MUNICIPALITY OF ANCHORAGE
PROJECT MANAGEMENT AND ENGINEERING DEPARTMENT

TASHA DRIVE RECONSTRUCTION
FLAMINGO DRIVE TO NORTHWOOD STREET

PM&E PROJECT NUMBER 20-15
SEPTEMBER 2025
95% DESIGN

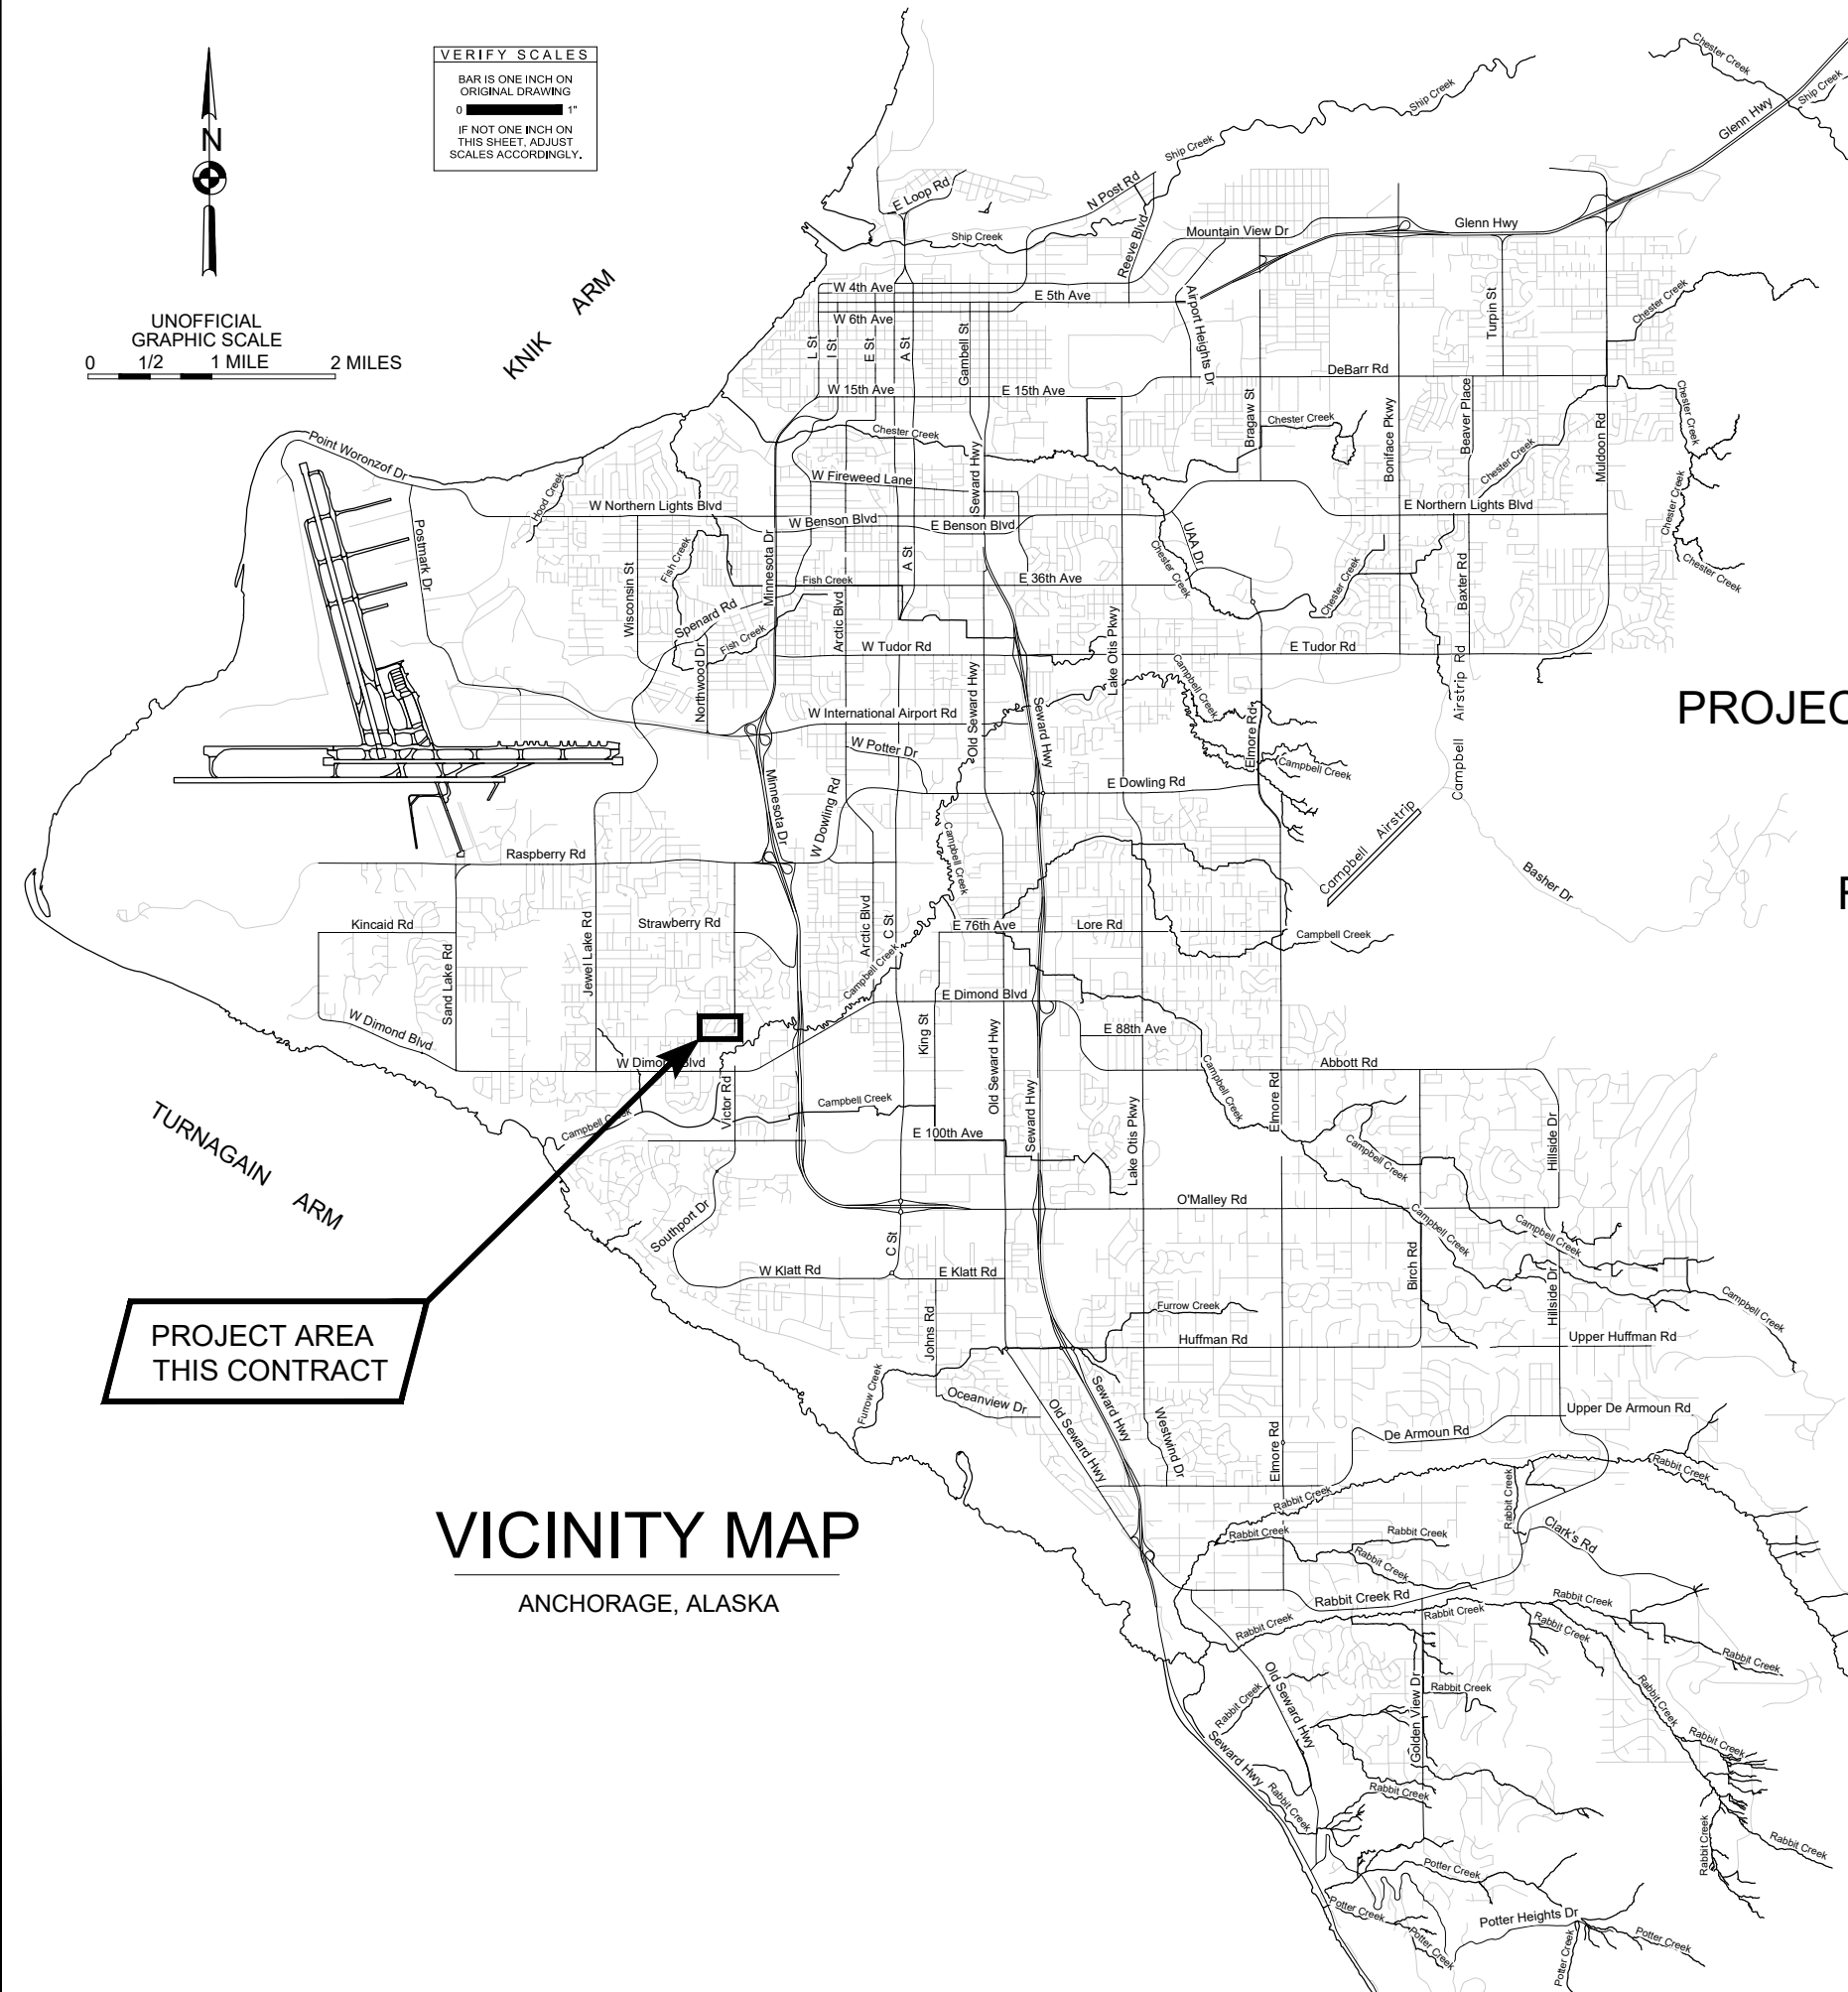
Sidewalk shown in 95% plans has been eliminated

1 **TYPICAL SECTION - FLAMINGO DRIVE**

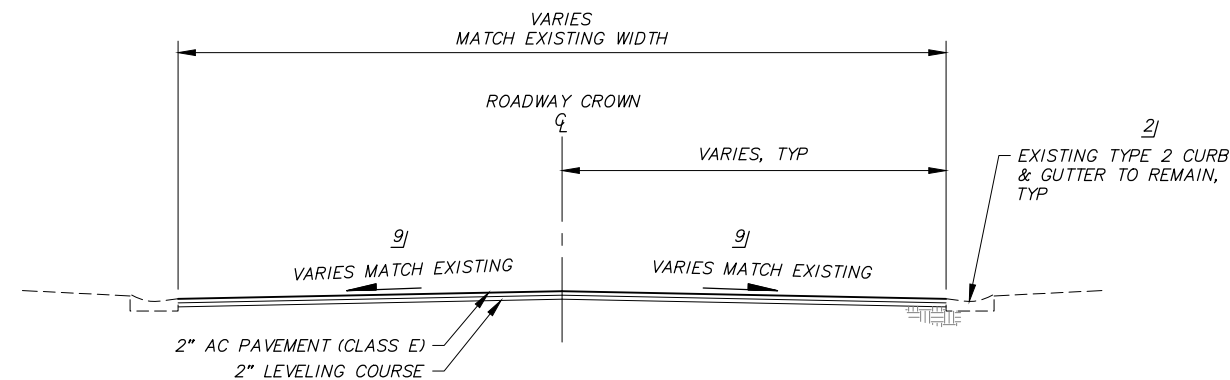
Sidewalk shown in 95% plans has been eliminated
